Regulation No. 48 (Installation of lighting and light-signalling devices)

Proposal for Supplement 8 to the 04 series of amendments

Submitted by the expert from the Working Party "Brussels 1952"*

The text reproduced below was prepared by the expert from the Working Party "Brussels 1952" (GTB) in order to increase the maximum mounting height of rear foglamps. The modifications to the existing text of the Regulation are marked in bold for new or strikethrough for deleted characters.

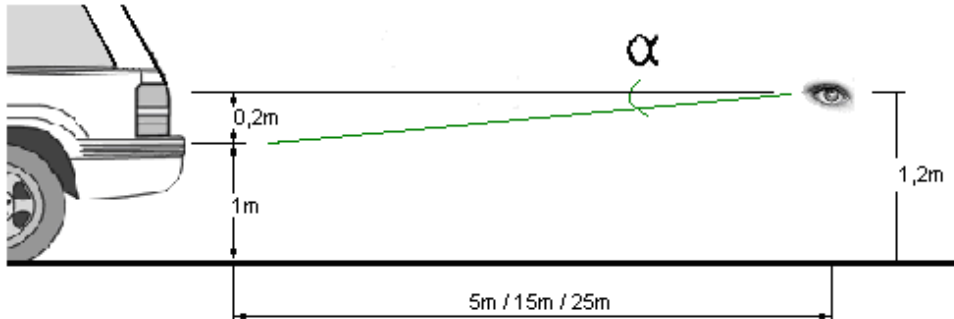
(a) The various situations relating to the observation angle of a rear fog lamp by a following driver were analysed to determine any possible increased glare effects due to a higher mounting height.

(b) The height of the eye point of the driver in a M₁ vehicle was taken to be 1.2 m (typically located between 1,000 and 1,500 mm).

(c) It is generally accepted that a safe separation distance for stopping from 30 km/h is 15 m, and for 50 km/h is 25 m. When vehicles are stationary the observation distance is approximately 5 m. These distances can be used to evaluate possible glare effects.

(d) The change (delta) in the observation angle for these three situations is calculated as follows:

Example:

- (i). Increasing the mounting height by 200 mm changes the angle α of observation by a following driver's eye as follows:

$\alpha = 2,3^\circ$ distance 5 m $\hat{=}$ vehicle at standstill

$\alpha = 0,8^\circ$ distance 15 m $\hat{=}$ vehicle speed 15 km/h

$\alpha = 0,5^\circ$ distance 25 m $\hat{=}$ vehicle speed 30 km/h

The light distribution of a rear fog lamp according to Regulation No. 38 is shown below:

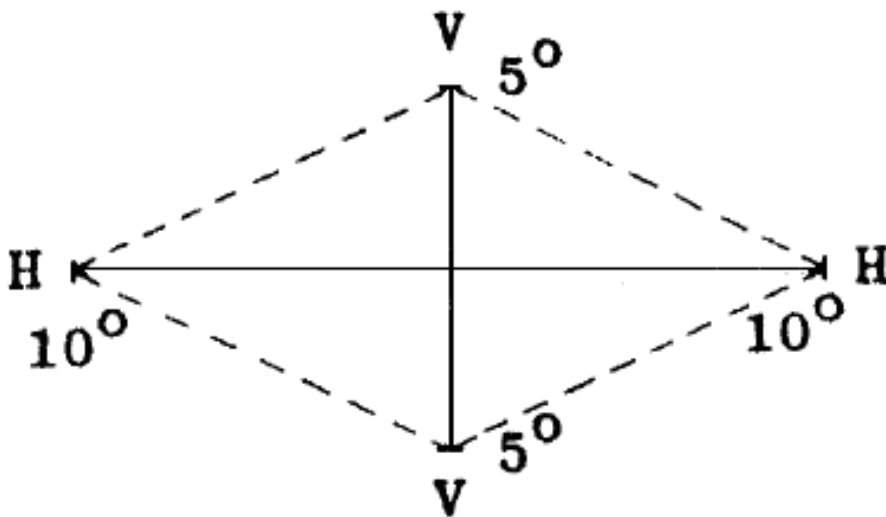
- (ii). Along the H-H axis between 10 degrees left to 10 degrees right and the V-V axis between 5 degrees up to 5 degrees down the luminous intensity shall not be less than 150 cd and not more than 300 cd. This

means that a small change in observation angle (2.3 degree, worst case) will not significantly affect the intensity perceived by the following driver.
